WORKING DRAFT OF NEC CODE-MAKING **PANEL 15 MEETING OUTPUT**

Document: National Electrical Code®

Revision Cycle: A2025

Meeting Dates: January 24 – 26, 2024

Figure Informational Note Figure 517.31(B)(1) Type 1 Essential Electrical System — Minimum Requirement (Greater Than 150 kVA) for Transfer Switch Arrangement.

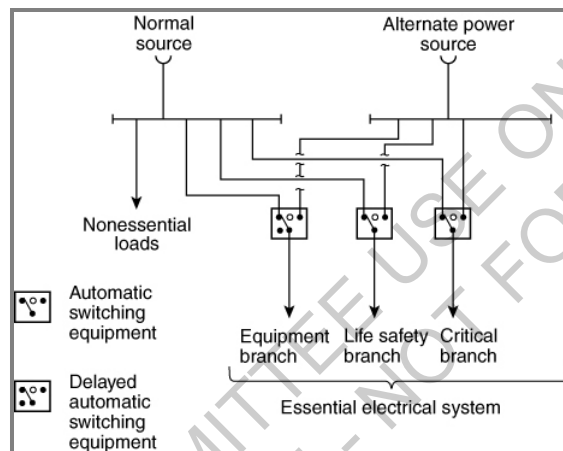
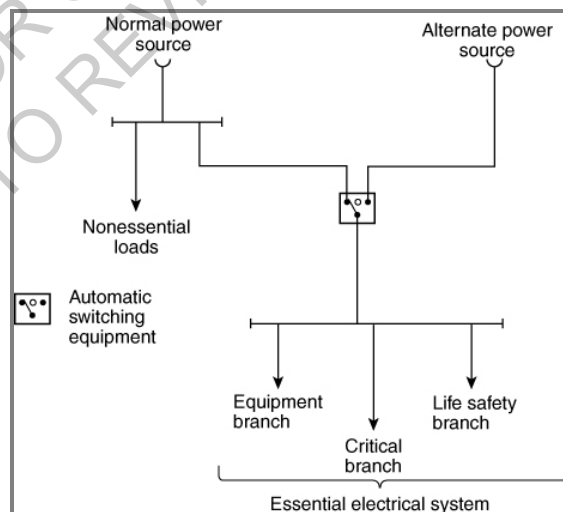
[Replace Figure 517.31(B)(1) below with "Figure 517.31(B)(1)" jpg file. Keep same title as above]

[Replace Figure 517.31(B)(2) below with "Figure 517.31(B)(2)" jpg file. Keep same title as above]

Figure Informational Note Figure 517.42(B)(1) Type 2 Essential Electrical Systems (Nursing Home and Limited Health Care Facilities) — Minimum Requirement (Greater Than 150 kVA) for Transfer Switch Arrangement.

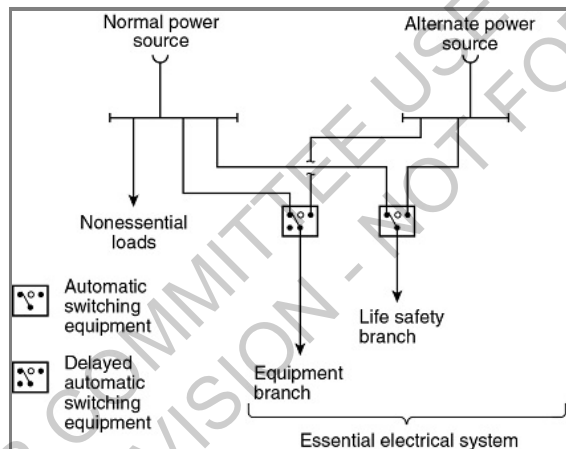
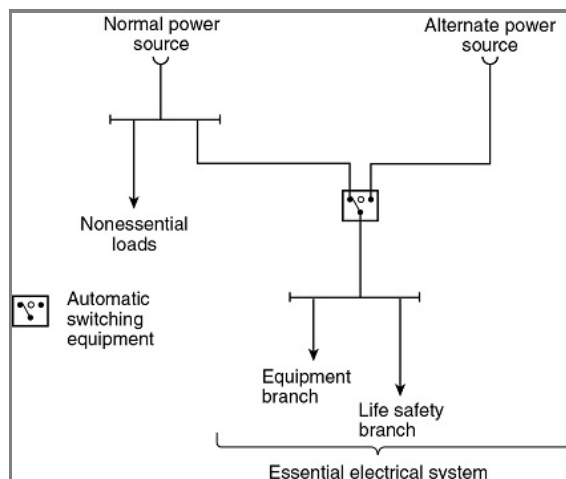
[Replace Figure 517.42(B)(1) below with "Figure 517.42(B)(1)" jpg file. Keep same title as above]

[Replace Figure 517.42(B)(2) below with "Figure 517.42(B)(2)" jpg file. Keep same title as above]

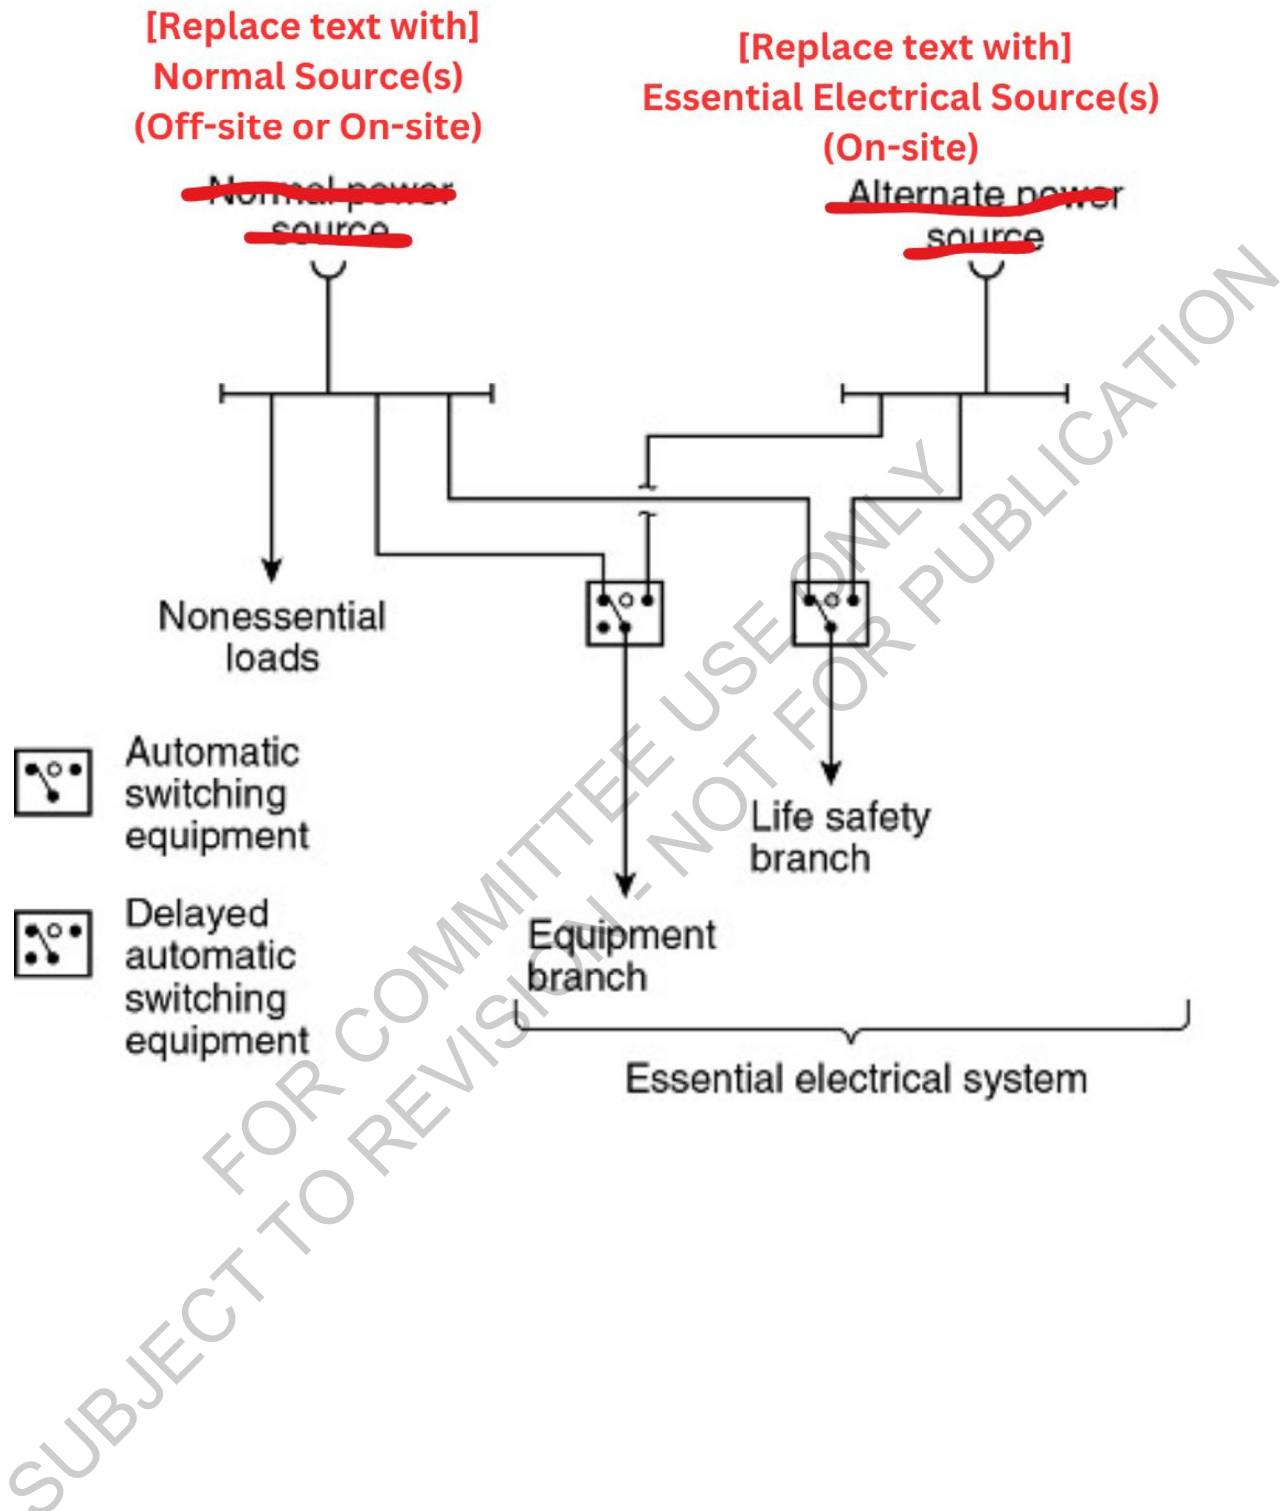
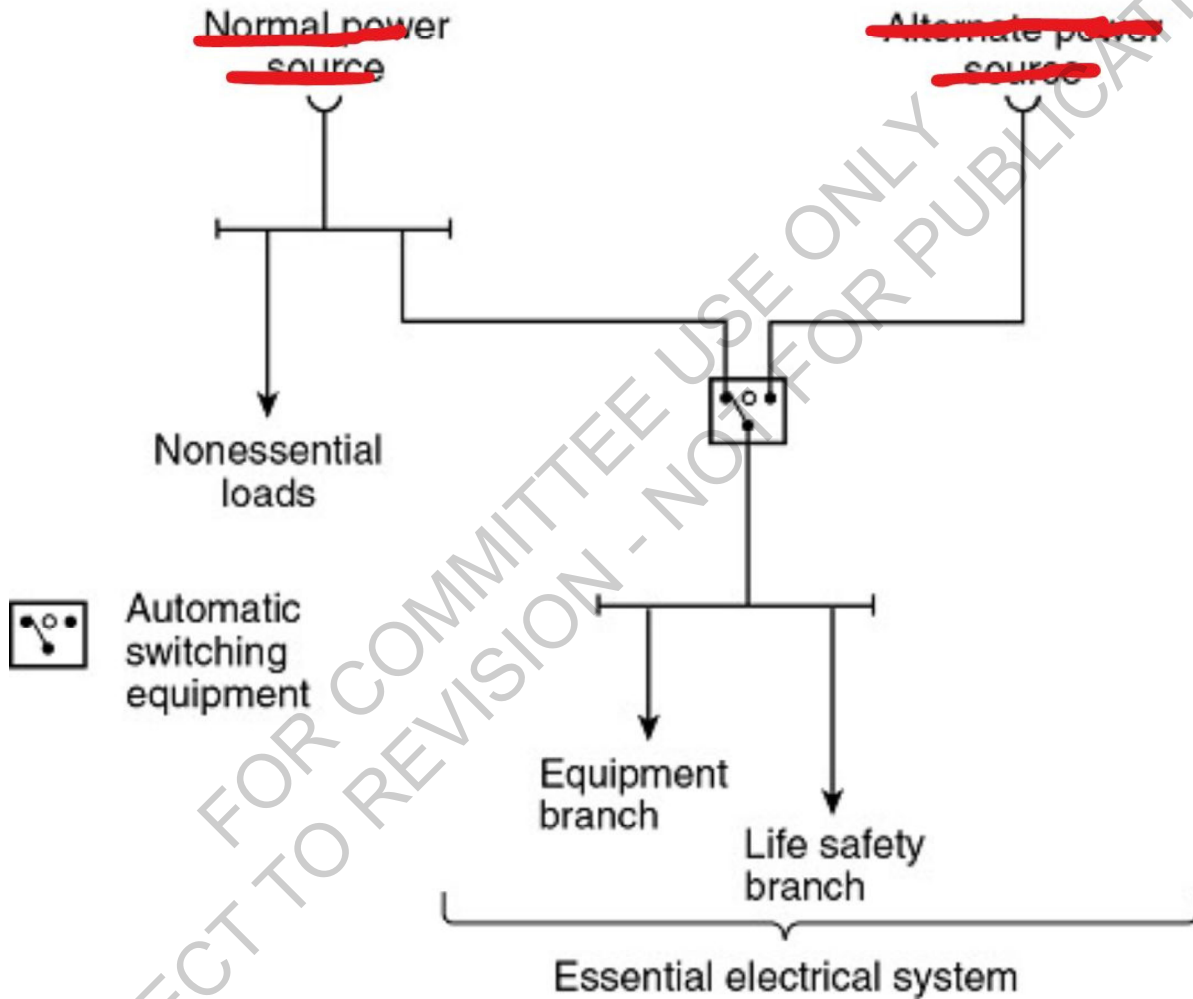
Committee Statement: The only time you can combine the loads on a single transfer switch on a type 2 system is if the total system load is 150 kVA or less on the EES. All other NFPA 99 extracts updated.

[Replace text with]
Normal Source(s)
(Off-site or On-site)

[Replace text with]
Essential Electrical Source(s)
(On-site)
